EEVC - WORKING GROUP 12 ADULT CRASH DUMMIES

ES-2 DUMMY: REVIEW OF OICA COMMENTS

DRAFT TECHNICAL DOCUMENT FOR DISCUSSION

OCTOBER 2002

Figure 1: Left: Time histories of rib deflection for five impact angles of the EUROSID prototype (Friedel et al. [4]). Right: Peak rib deflection for five impact angles in high-mass impacts on the EUROSID-1 production version (Maltese et al. [5])

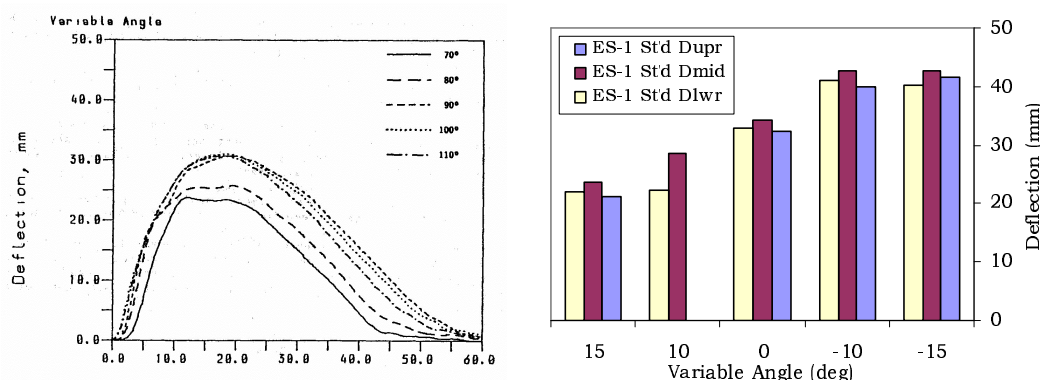
In the OICA report [3], the authors draw the attention to the thorax performance of the ES-2 dummy in off-axis loading. This case is believed to be important since in full scale testing the loads to which the dummy is exposed often include off-axis components. During the EEVC evaluation program, the ES-2 dummy was subjected to pendulum impacts at -20°, -10° (rearward), 0° (perpendicular), +10° and +20° (forward) angles. As the ES-2 rib guide system and point of displacement measurement are different from the EUROSID-1, the objective was to study the effect on the directional sensitivity of the dummy (see Annex D of the EEVC report [1]). The authors are surprised that ES-2 produces higher measured deflections at rearward oblique than at lateral impacts and claim that no data exist on the production EUROSID-1 to make a proper comparison.

Firstly, reference is made to EEVC pendulum tests performed by Friedel et al. [4] on the EUROSID prototype which, according to the authors, show the prototype EUROSID was insensitive to impact angles. Figure 1 below (left), reproduced from Friedel et al. [4] shows angular sensitivity of the EUROSID prototype with deflection values getting larger as the angle of impact increase from 70° and constant values for 90° to 110° (Note: the definition used in Friedel et al. being: 0° for front, 90° for side and 180° for rear impact). This plateau effect is typical for the EUROSID prototype which had an optical system that measured deflection directly on the piston. Later on, this design was changed and a potentiometer was placed between the piston and damper (slightly more forward of the optical system) for the production version EUROSID-1. This change has affected the directional sensitivity of EUROSID-1 compared to the original EUROSID prototype.

Directional impact data on EUROSID-1 production dummy have been published in 1999 by Maltese et al. [5]. This NHTSA study into the response of the EUROSID-1 thorax to lateral impact, uses a high-mass Part 581 bumper testing pendulum to load the dummy at discrete angles ranging from frontal oblique to rearward oblique. Figure 1 (right) shows the peak rib deflections as a function of impact angle for upper, mid and lower ribs. This figure shows higher deflection values for rearward oblique impact angles, as is the case for ES-2. It should be noted that “flat-tops” occurred in the frontal oblique conditions, both in the original EUROSID prototype tests as during the NHTSA tests with EUROSID-1.

In conclusion, EUROSID prototype, EUROSID-1 and ES-2 show a very similar trend regarding oblique loading i.e. lower readings in forward oblique and higher readings in rearward oblique impacts. This is explained by the design of the rib structure and location of actual measurement point. Changes in directional sensitivity between EUROSID-1 and ES-2 are caused by changes in rib friction and a small shift in point of measurement as explained in the EEVC report [1]. In general, the (change of) sensitivity of the parameters studied is found to be acceptable.

Figure 2: Left: Comparison of peak rib deflection for five impact angles of EUROSID prototype (Friedel et al. [4]); Right: Mean peak rib deflection for each impact angle from TRL ES-2 prototype evaluation, showing the effect of permanent deformation of two tuning springs [3].

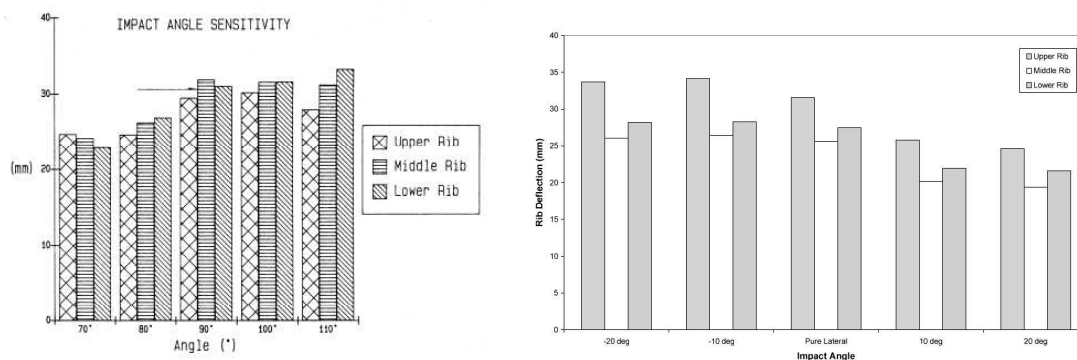
In the OICA report [3], the authors have noticed a lack of inter-rib homogeneity in the rib responses reported by EEVC. In sled tests, for instance, it is noted that not all ribs follow the same pattern suggested by the calculated average deflection and V^*C , instead individual ribs may deviate from each other. Reference is made to Friedel et al. [4] which data suggest a continuous evolution from lower to upper rib for the EUROSID prototype. For comparison, mean peak rib are included in the OICA report [3], taken from the TRL test report (Figure 2, right).

The question to answer is whether it is justified to assume inter-rib homogeneity? The reference data on the EUROSID prototype that the authors refer to, are shown in Figure 2 (left) below. Indeed, this figure suggests a continuous evolution from upper to lower rib, except for the pure lateral case. It should be noted, however, that the data for frontal oblique tests are suspect as there is clear evidence for flat tops in these (see Figure 1, left). Evidence on the EUROSID-1 production version can be found in the NHTSA data [5] (Figure 1, right) that show discontinuity of upper, mid and lower ribs instead.

Still, the ES-2 data presented by OICA [3] give reason for further analysis. Firstly, it is observed in Figure 2 (right) that the mid rib deflection is always lower than upper and lower rib deflection. This may still be as it should be, if the peak values occur at different moment in time due to the overall dummy kinematics. Still, going back to the original data and test set-up, it appears that the ES-2 ribs at TRL had a slight off-set with respect to each other, caused by permanent deformation of the tuning spring of two ribs. Annex B of this report further investigates this concern and reports on additional impactor tests to study inter-rib

homogeneity. These new tests clearly demonstrate a good overall correlation between EUROSID-1 and ES-2 dummies and confirms that both exhibit identical individual rib response in laboratory test conditions.

Figure 4: Aft view of thorax left to right: Lower rib 2 mm permanent deformation, middle rib 3 mm permanent deformation and upper rib on the nominal position.

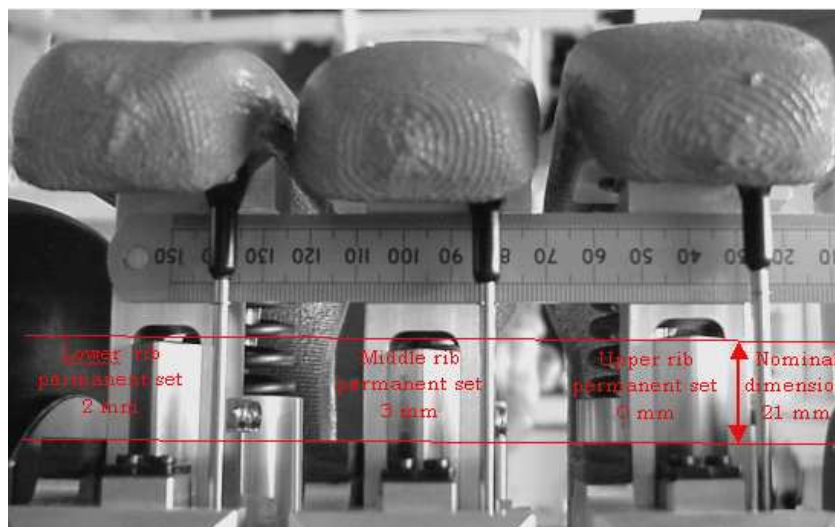
3. Inter-rib homogeneity: the evolution of responses between EUROSID-1 and ES-2 are not continuous. This aspect is not addressed and would have a greater influence on maximum deflection and V*C values for individual ribs than on the average values for the three ribs highlighted in the EEVC report.

The thorax assembly used at TRL for the sensitivity evaluation suffered from some permanent deformation of the tuning springs as a result of over-loading at earlier tests. Figure 4 shows a picture of ES-2 Prototype –004 before testing at TRL: the upper rib appears to be on nominal position. Both other ribs show a permanent set of 3 mm and 2 mm for middle and lower rib, respectively. Figure 2 in the OICA report showing the mean peak rib deflection for each impact angle therefore includes the effect of this permanent set.

Figure 6: Renault Megane rib deflection signals [2]

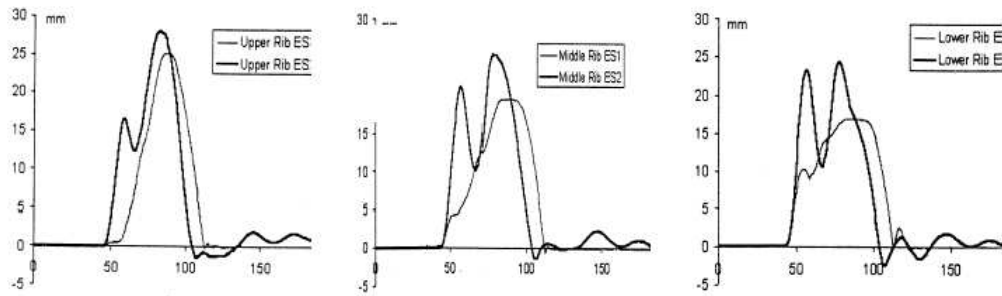
Furthermore, the authors claim oscillations observed in some vehicle tests (most notably the Renault Megane test) are a consequence of elastic rebound of the thorax, governed by the natural frequency of the rib module. While no evidence is presented to support this statement, it renounces the analysis of eigenfrequency included in the EEVC report [1] (which does include the stiffness of the rib itself, see Annex F, page 29 and further). No attempts are made to investigate the most plausible cause of this phenomenon put forward by EEVC, i.e. the occurrence of multiple loading applied to the thorax.

The concern on the thorax damping brought up by OICA relates to a certain aspect of the full scale results, which is most clearly illustrated by the Renault Megane test. The EEVC report on ES-2 includes the figure below, taken from the ACEA test report [2] that shows double peaks of the deflection responses. Analysis of these signals shows that the rib speed in the first loading curve on average are approximately 1.8 m/s (upper), 2.5 m/s (middle) and 3.0 m/s (lower) respectively, and 1.3 m/s (upper) 1.8 m/s (middle) and 1.8 m/s (lower) in the second loading curve. The authors suggest that the double peak is due to rib system oscillation (in this case at frequency of approximate 50 Hz).

Figure 11: Overshoot and relative overshoot of ES-2 versus EUROSID-1

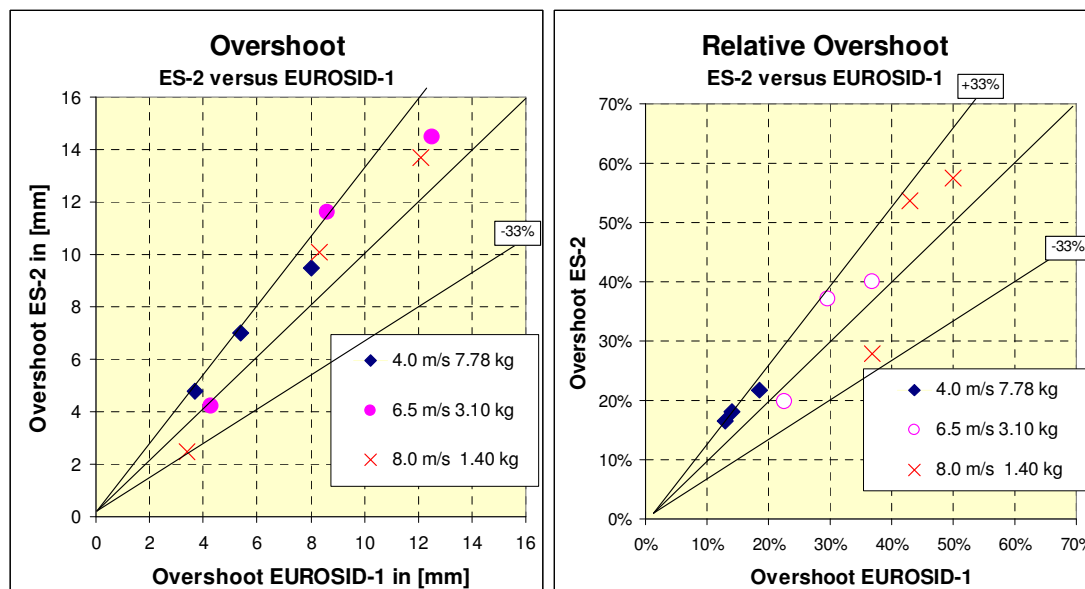
Probably the most pertinent of the issues raised by OICA is the thorax damping characteristics and stiffness. The authors are concerned that the reduced friction damping and increased tuning spring stiffness in ES-2 have resulted in less appropriate humanlike thorax behaviour and an oscillatory response.

The consolidated results for all tests conditions are given in Table 5. A graphic summary of the overshoot and the relative overshoot is given in Figure 11. The overshoot and relative overshoot for ES-2 are in all but two cases higher than EUROSID-1. The differences between ES-2 and EUROSID-1 are all within 33% relative to EUROSID-1.

In summary, with regards to the rib oscillation seen in the Renault Megane full-scale test result, the following conclusions can be drawn from this study:

- The rib velocities in the full scale Renault Megane test are approximately: 1.8 m/s (upper) 2.5 m/s (middle) and 3.0 m/s (lower) in the first loading curve, and 1.3 m/s (upper) 1.8 m/s (middle) and 1.8 m/s (lower) in the second loading curve; the tests velocities in this programme vary from 4.0 to 8.0 m/s and are therefore close to the maximum velocity and higher.
- The ES-2 rib assembly does not show any rib oscillation of the magnitude seen in the full-scale test during the overshoot phase. It is far more likely that a second loading curve is a direct result of a second impact;
- The overshoot found in the stopped impactor tests with ES-2 show the same characteristic as the found for EUROSID-1, however, is up to 33% higher than those found with EUROSID-1 in the same test condition.
